17-7295 Access Park, Gloucester

Road Safety Audit Stage 2

Designer responses to the Stage 2 Road Safety Audit conducted by Mott MacDonald during October 2022:

Figure 4: Zebra crossing markings provided at Toucan and Uncontrolled crossings.

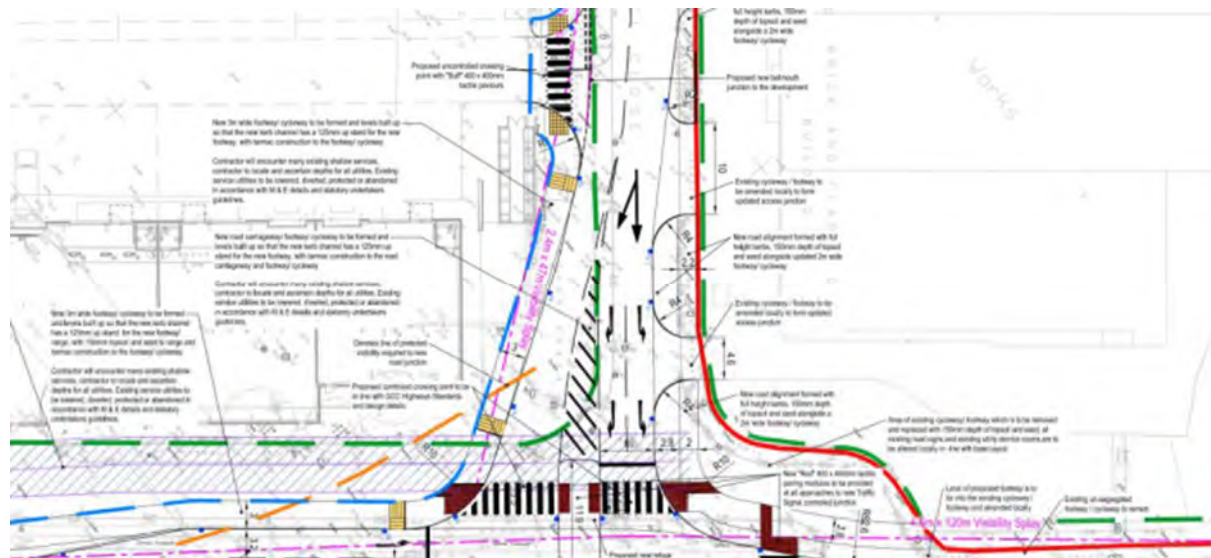
Summary: Incorrect provision of Zebra crossing markings may lead to confusion. A number of Toucan crossings and uncontrolled pedestrian / cyclist crossings are present throughout the scheme. At all of these, black and white Zebra crossing markings are proposed. The provision of such markings may lead pedestrians / cyclists to believe that the crossings are Zebra crossings and begin to cross into the path of approaching vehicles who may not be expecting to stop. This may lead to collisions between pedestrians / cyclists and vehicles.

It is recommended that all Zebra crossing markings are omitted from the scheme. The crossing studs should also be omitted from the uncontrolled crossing points.

We concur with the recommendations made and have removed all zebra crossings as well as the crossing studs from the uncontrolled crossings.

Figure 5: Example of ‘Tramline’ and ‘Ladder’ corduroy tactile paving.

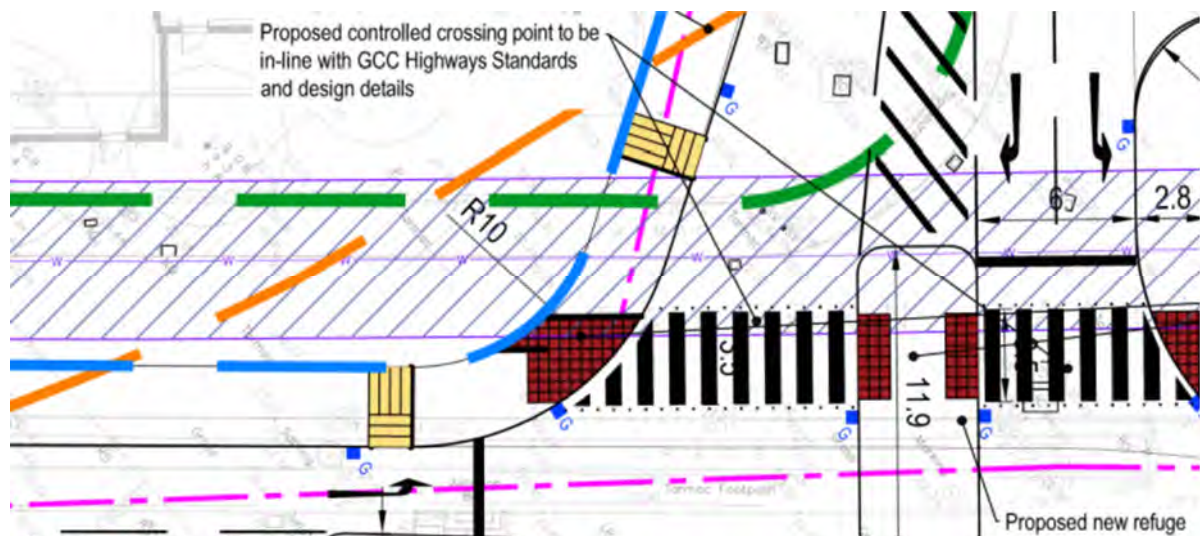
Summary: Incorrect provision of ‘Tramline’ and ‘Ladder’ corduroy tactile paving. ‘Tramline’ and ‘Ladder’ corduroy tactile paving is shown at various locations on the widened unsegregated shared use footway / cycleway. The use of ‘Tramline’ and ‘Ladder’ corduroy tactile paving indicates to users the presence of a segregated shared use facility. As such pedestrians or cyclists may wrongly believe that the other user will not be present on the footway / cycleway increasing the risk of collisions between the two user types.

It is recommended that corduroy tactile paving is correctly provided in accordance with the

Department for Transport's 'Guidance on the Use of Tactile Paving Surfaces' (DfT, 2022). Given that no existing corduroy paving is present on the shared use footway / cycleways that the scheme ties into, it may be appropriate that the 'Tramline' and 'Ladder' corduroy tactile paving is omitted from the scheme to provide consistency along the route.

We agree with the later part of the recommendation that the 'Tramline' and 'Ladder' corduroy tactile paving is omitted from the scheme to provide consistency along the route, as no 'Tramline' or 'Ladder' corduroy tactile pavements are installed on the existing network.

Figure 8: Inappropriate provision of 'in line' crossings.

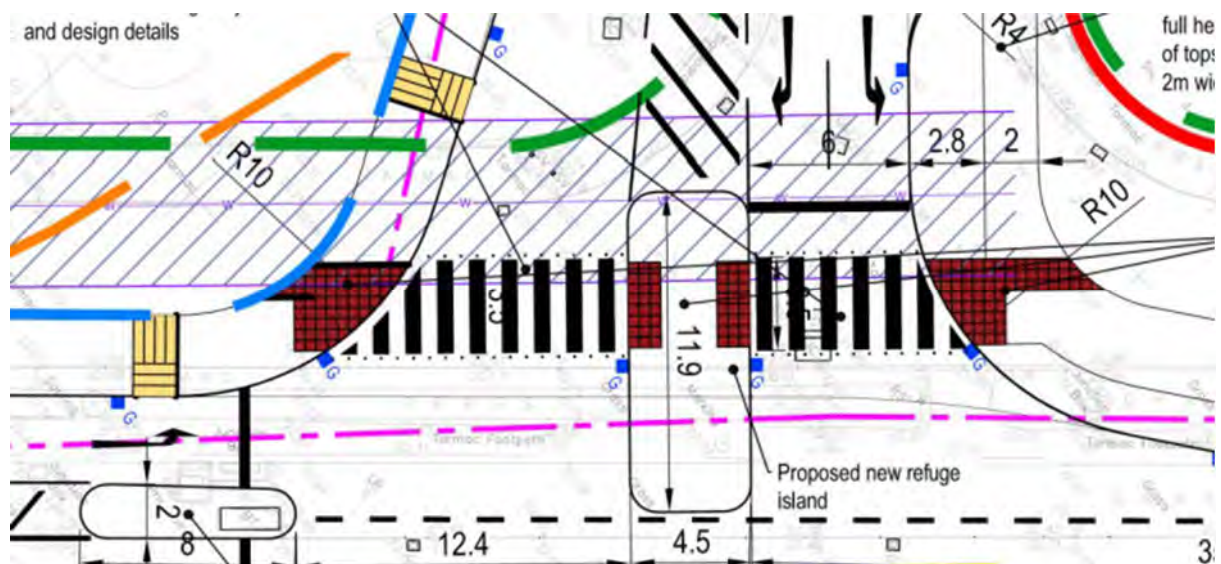
Summary: Separate 'in line' Toucan crossings may result in pedestrian / cyclist collisions. New Toucan crossings are proposed across Chancel Close. These are to be provided 'in line', However, the traffic signal staging indicates that these will operate as separate phases. Pedestrians / cyclists may mistakenly believe that the Toucan crossings are provided as a single crossing and attempt to cross in a single movement without waiting in the central island, increasing their vulnerability to being struck by passing vehicles.

It is recommended that either a 3.0m stagger between the crossings is provided.

We concur with the recommendation and have updated the layout to show a 3.0m stagger between crossing points.

Figure 9: Incorrect tactile paving arrangement.

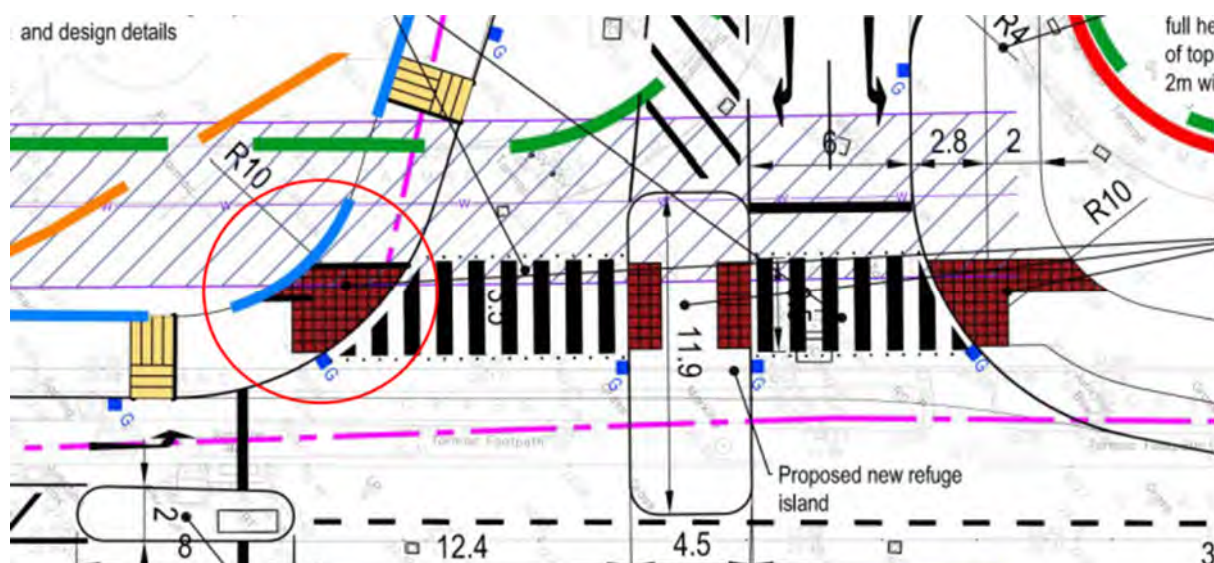
Summary: Incorrectly located stem of tactile paving may mislead crossing pedestrians / cyclists. New Toucan crossings are proposed across Chancel Close. On the southern side of Chancel Close, the stem of the 'L' tactile paving is positioned on the side furthest from approaching traffic. The stem should be provided on the side from which traffic is approaching. As such, pedestrians / cyclists, and particularly visibility impair users, may fail to correctly anticipate approaching vehicles increasing their vulnerability to being struck by passing vehicles.

It is recommended that the stem of the 'L' tactile paving on the southern side of Chancel Close is correctly positioned so that it is on the side of approaching traffic.

We concur with the recommendation and have updated the layout to show the correct setting out of tactile pavements, also this crossing point has been modified to have a 3.0m stagger between crossing points, in-line with the crossing point across Eastern Avenue.

Figure 10: Misleading provision of 'left green arrow'.

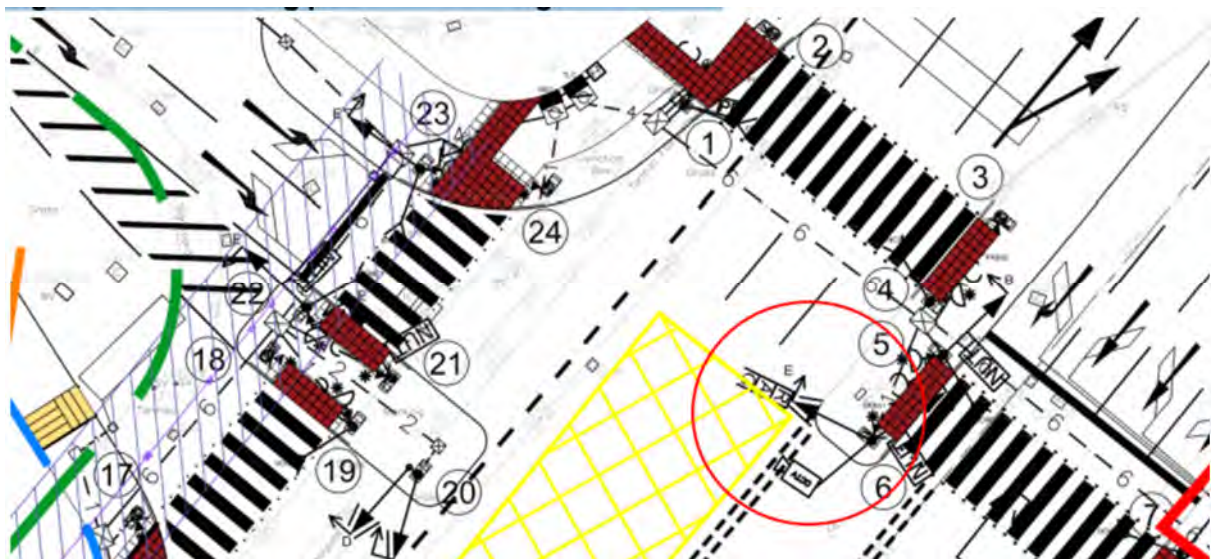
Summary: Chancel Close secondary signal shows 'left green arrow' only. Primary 'left green arrow' and 'right green arrow' signal heads are proposed on Chancel Close at its junction with Eastern Avenue. However, the secondary signal shows a 'left green arrow' only. This arrangement may lead to driver hesitation increasing the likelihood of rear end shunts.

It is recommended that a secondary 'right green arrow' is also provided.

We concur with the recommendation and a secondary right green arrow should be provided.

Figure 11: Inappropriate provision of ‘Give way’ markings.

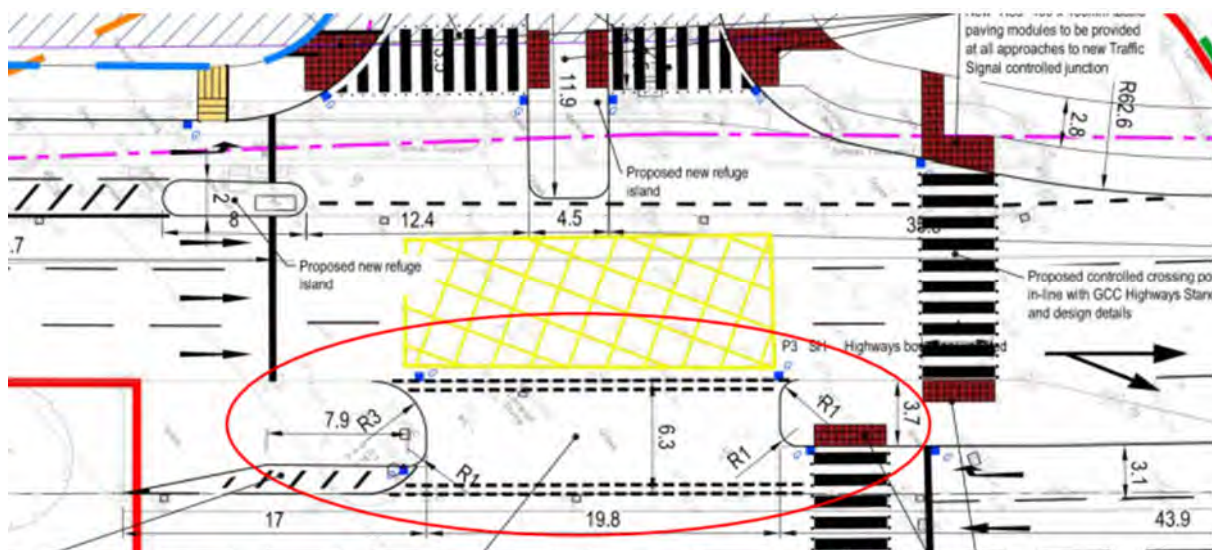
Summary: Incorrect provision of ‘Give way’ markings may lead to driver hesitancy. ‘Give way’ markings to TSRGD 2016 Diagram No. 1003 are proposed within the central reserve gap at the junction between Eastern Avenue and Chancel Close. The traffic signal staging indicates that no motorists turning right into or out of Chancel Close are required to give way at this location. The presence of such markings may result in motorists hesitating or unexpectedly braking leading to an increased risk of rear end shunt type collisions.

It is recommended that the 'Give way' markings (TSRGD 2016 Diagram No. 1003) are replaced with 'edge of carriageway' markings.

We concur with the recommendation and have updated the proposed road markings to suit.

Figure 13: Proposed position of pedestrian / cyclist push button demand units.

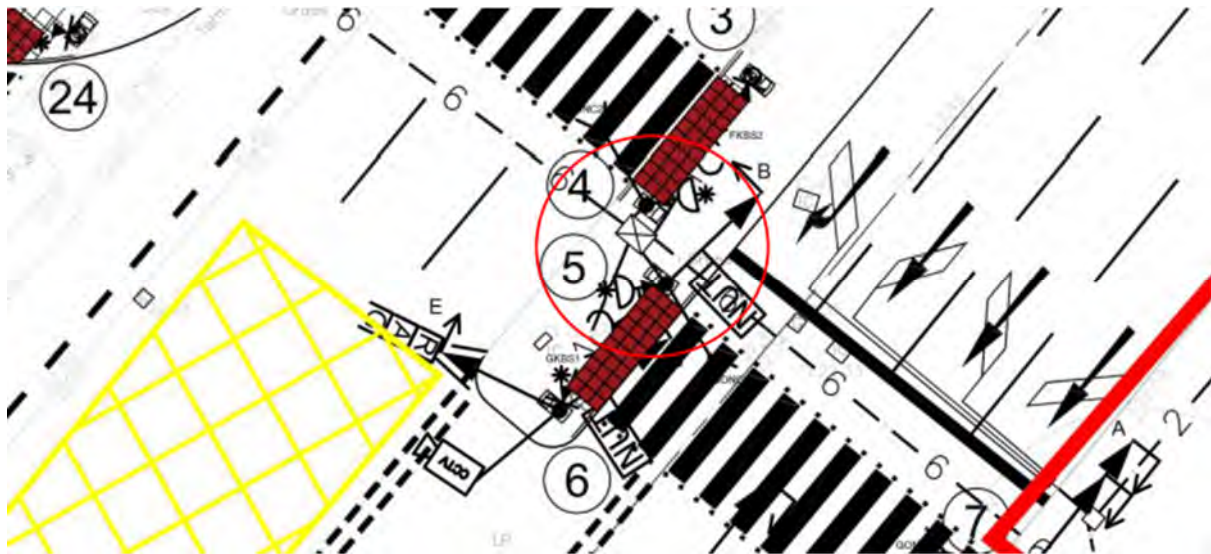
Summary: Insufficient gap between traffic signal equipment on central island. A new staggered Toucan crossing is to be incorporated across Eastern Avenue on the northern side of the new signalised junction. Though the width of the central island is stated as being 3.7m wide, the width of the 'stagger' and the position of the traffic signal equipment appears to result in a 'pinch point' that may hinder the safe movement of pedestrians and / or cyclists leading to collisions between users or with the signal equipment.

It is recommended that a minimum 3.0m stagger between the two crossings is provided. It is noted that at a crossing such as this one, tactile paving is only required to be 800mm deep.

Removing the additional row of tactile paving may assist with achieving greater separation.

We concur with the recommendation and have updated the crossing point.

Figure 14: Lack of traffic island may result in hesitation and confusion.

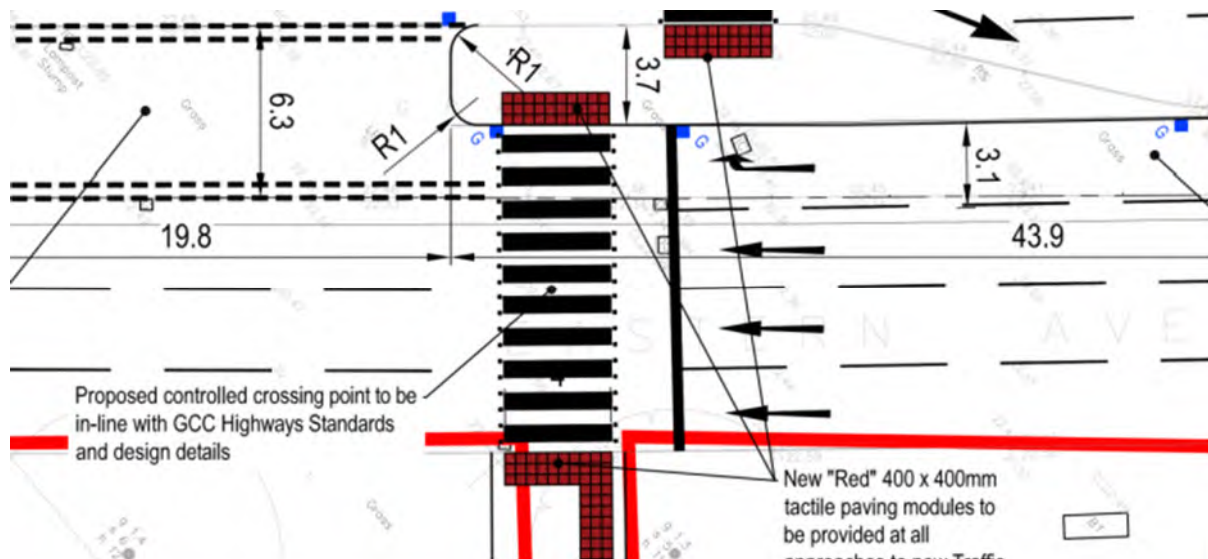
A new right turn lane is proposed on the southbound Eastern Avenue at its junction with Chancel Close. This will be separately signalled from the three existing 'Ahead only' lanes. However, no physical separation is provided between the 'Ahead only' and 'Right turn' lanes. As such, motorists may be unclear if they are required to stop, increasing the likelihood of inappropriate braking leading to rear end shunts or failure to stop resulting in turning related collisions.

Furthermore, pedestrians / cyclists using the Toucan crossing may observe right turning traffic stopping and begin to cross assuming all traffic has received a red signal. This increases the risk of collisions involving crossing pedestrians / cyclists.

It is recommended that a traffic island incorporating appropriate traffic signals is provided between the 'Ahead' and 'Right turn' lanes.

We concur with the recommendation and have added a traffic island to separate the 'Ahead' and 'Right turn' lanes.

Figure 16: Two sets of Stop lines provide on north-eastbound Eastern Avenue.

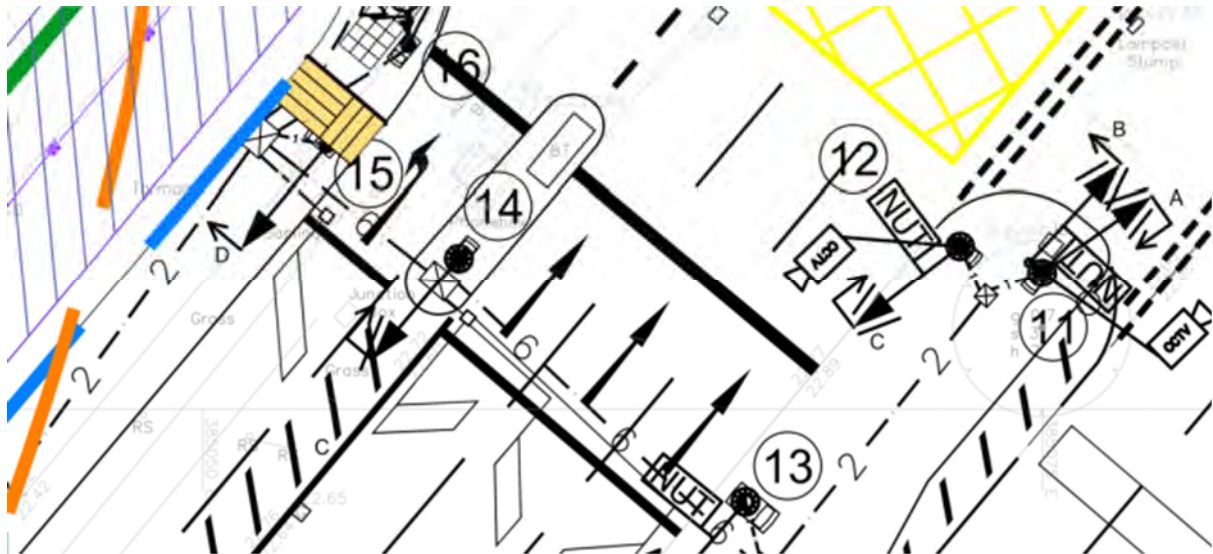
The traffic signal design drawings show two sets of Stop lines for the northbound Eastern Avenue, one in advance of the primary signal heads and one beyond them. Provision of two sets of Stop lines is likely to result in driver confusion and hesitation as the point at which to stop will be unclear. This is likely to lead to an increased risk of rear end shunt type collisions.

It is recommended that the Stop lines located beyond the primary signal heads are omitted from the design. Relocate the carriageway arrow markings prior to the retained Stop lines.

We agree with the comment made and have updated the road markings to suit.
